SERVICE BULLETIN

B-086

BUELL SAFETY RECALL 0837 XB12XT/P WINDSHIELD KIT

Figure 1. Windshield Removal

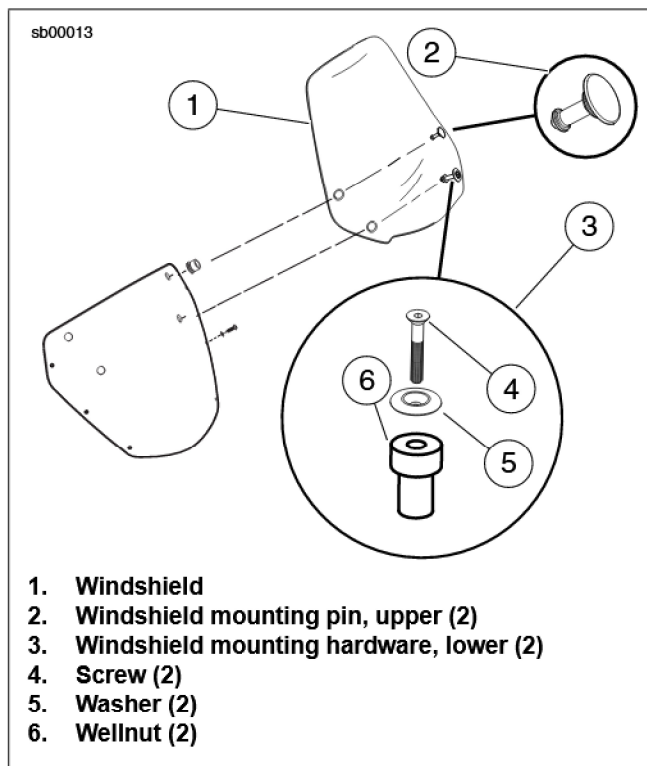
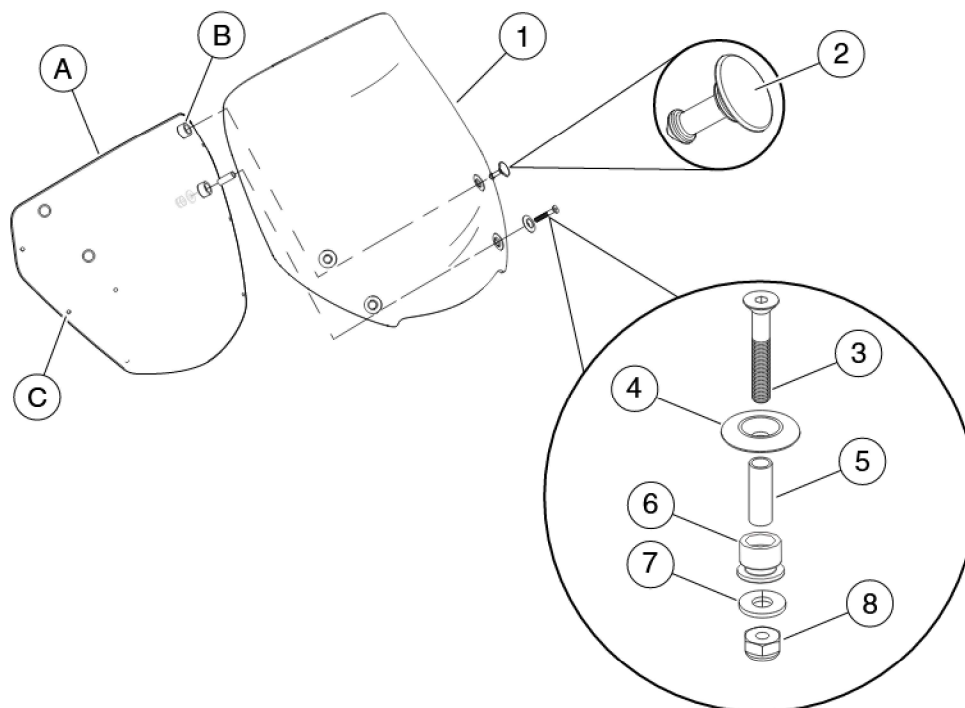
See Figure 1. The windshield is secured to the windscreen using two screws (4) with well nuts (6) and two mounting pins (2).

After removing the lower windshield mounting hardware, it will be necessary to pull the windshield loose from the windscreen by pulling upward sharply at the upper mounting pins.

1. Remove windshield mounting hardware (3) securing the windshield to the windscreen and pull windshield from windscreen. Discard lower windshield mounting hardware.
2. Pull windshield loose from the windscreen by pulling upward sharply at upper mounting pins.
3. Remove six fasteners from windscreen, and remove windscreen from motorcycle.

1. See Figure 2. Install windshield (1) by pushing upper mounting pins (2) into place. Verify upper mounting pins on windshield locate properly into upper bodywork mounting grommets (B) of windscreen (A).
2. Align lower windscreen (A) and windshield holes. For left and right side lower holes, insert finish washer (4) and spacer (5) onto screw (3) and place through windshield, grommet, and windscreen holes.
3. Install bodywork mount grommets (6) from kit into lower holes in windscreen.
4. From inside of windscreen, place washer (6) onto screw (3) and thread lock nut (7) onto screw. Tighten screw to 25-30 in-lbs (2.8-3.4 Nm).
5. Install windscreen (A) (with windshield attached) using six screws removed earlier. Tighten screws to 10-12 in-lbs (1.1-1.4 Nm).
